Official Transcript of Proceedings
NUCLEAR REGULATORY COMMISSION

Title: Advisory Committee on Reactor Safeguards
 US EPR Subcommittee: Open Session

Date: Monday, November 14, 2011

The purpose of the meeting is to continue our review of the SER with Open Items for the design certification document submitted by AREVA NP for the US EPR design and the SER with Open Items for the combined operations licence application submitted by UniStar for the Calvert Cliffs nuclear power plant Unit 3.

9.2.8 SCWS-Challenges

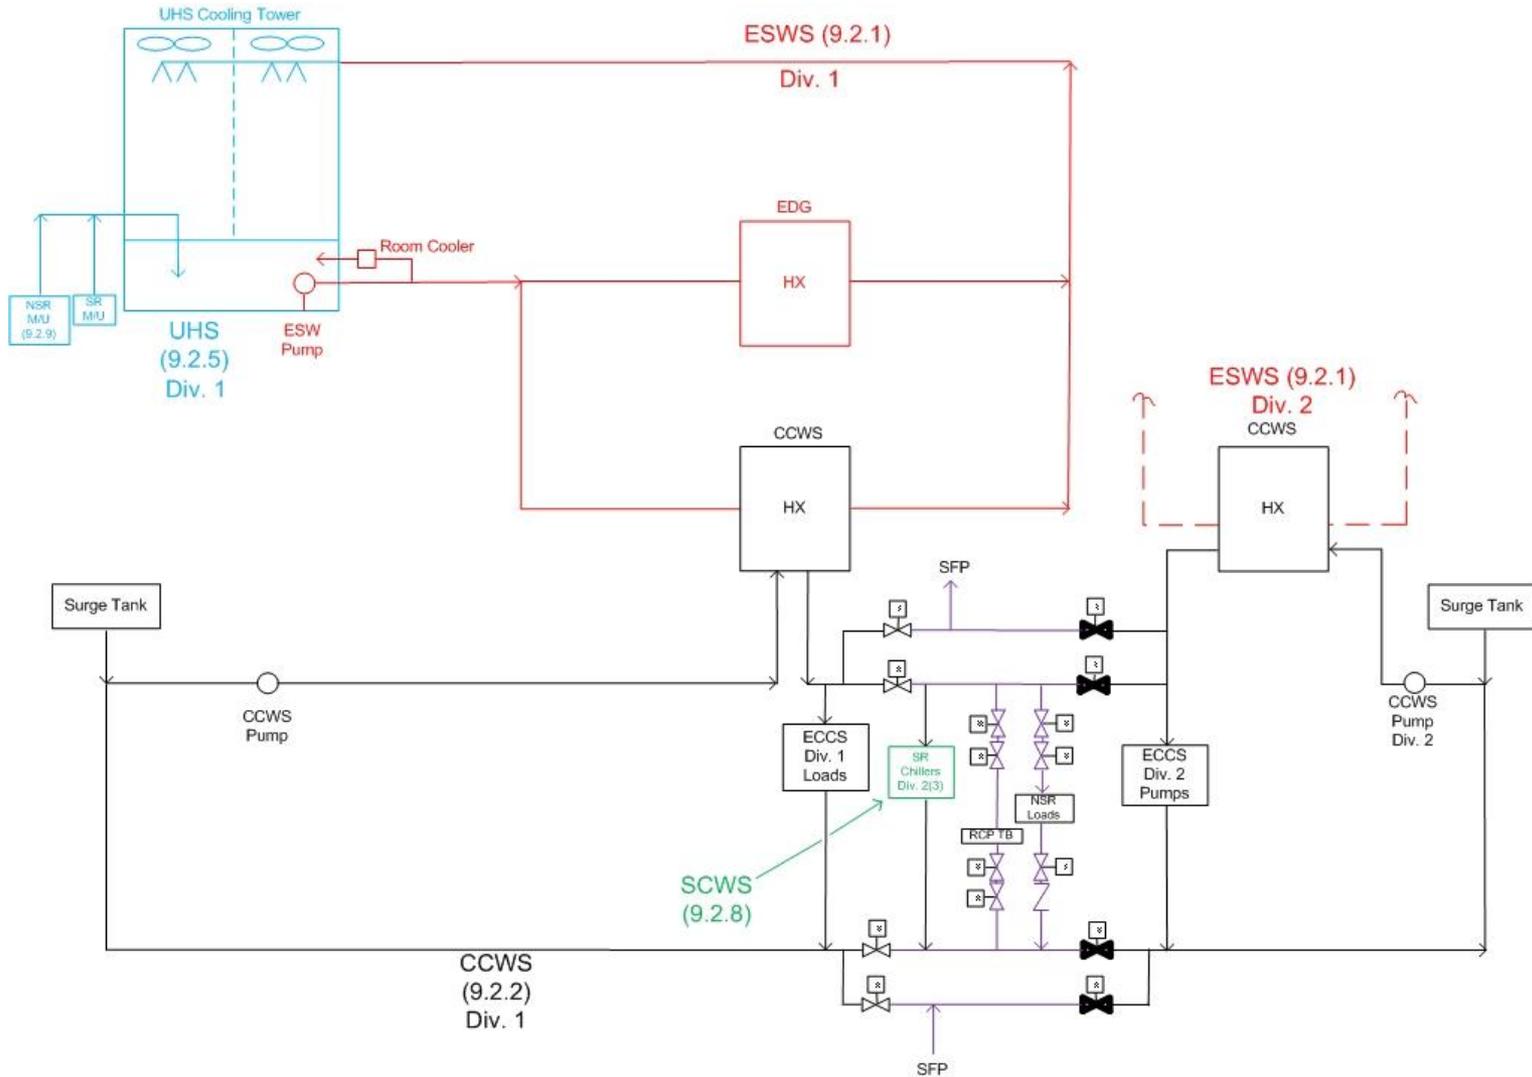
- **SCWS Water Hammer Considerations**
 - FSAR R/2 modified to add clarification:
 - Pressurized expansion tanks with nitrogen
 - Specified closing valves speed- slow enough to prevent damaging pressure increases
 - Chapter 14 testing – tests to verify there is no evidence of a water hammer

- **SCWS Surge Tank Sizing and System Leakage**
 - FSAR Revision 2 & 3 modified to add clarification:
 - 100 gallon water reserve for 7 day
 - Assumes no safety related makeup for 7 days
 - TS SR 3.7.9.4 leakage verification (24 months), < 0.5 gallon per hour
 - Defense-in-depth makeup from nonsafety-related Fire Protection (seismic Cat. II)
